AIRWORTHINESS DIRECTIVE

Robinson R44 Series Helicopters

AD/R44/20 **Main Rotor Swashplate and Tail Rotor Bolts** **1/2004**
TX

Figure 1

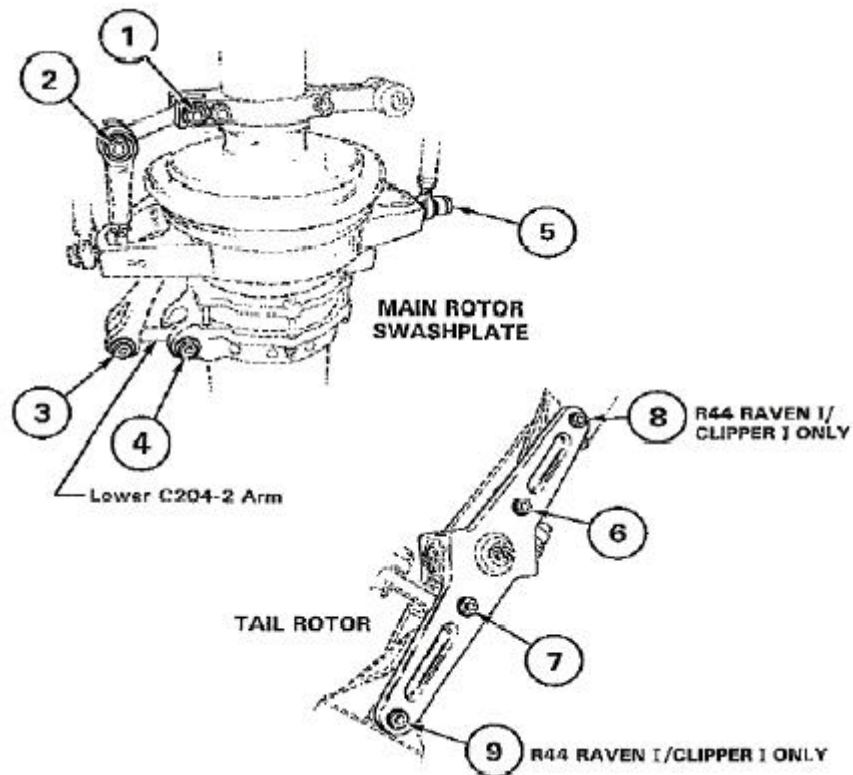
- Requirement: 1. For all R44 and R44 II helicopters except those serial numbers specified in Requirement 2 of this Directive:
- a. Determine if maintenance has been performed after 7 February 2003 on the areas specified in Figure 1 of this Directive, and determine if any bolt, part number NAS6605-31, shown on Figure 1 has been replaced for any reason.

- b. If any bolt has been replaced, or if it is uncertain whether any bolt has been replaced after 7 February 2003, remove the paint from the bolt head to reveal the vendor identification marking. Determine if the bolt vendor identification is 01DO.

3. For the helicopters affected by Requirements 1.b.(i) and 2. of this Directive, accomplish the following:
- a. Visually inspect each bolt for fretting residue under the bolt head, which indicates a loose, potentially cracked bolt.

- b. Apply 10-15 ft-lb (13-20 Nm) torque to each bolt head and verify no rotation. See Figure 1 of this Directive.
 - c. If residue or rotation of the bolt is found, replace each affected bolt with a serviceable bolt that does not have a vendor identification marking of 01DO.

4. For the helicopters affected by Requirements 1.b.(i) and 2 of this Directive, replace each bolt, part number NAS6605-31, that has vendor identification marking 01DO on the bolt head, with a serviceable bolt, part number NAS6605-31, that has an alternative vendor identification marking.

Bolt part number NAS6605-31 with vendor identification marking 01DO on the bolt head, is not to be installed on any helicopter.
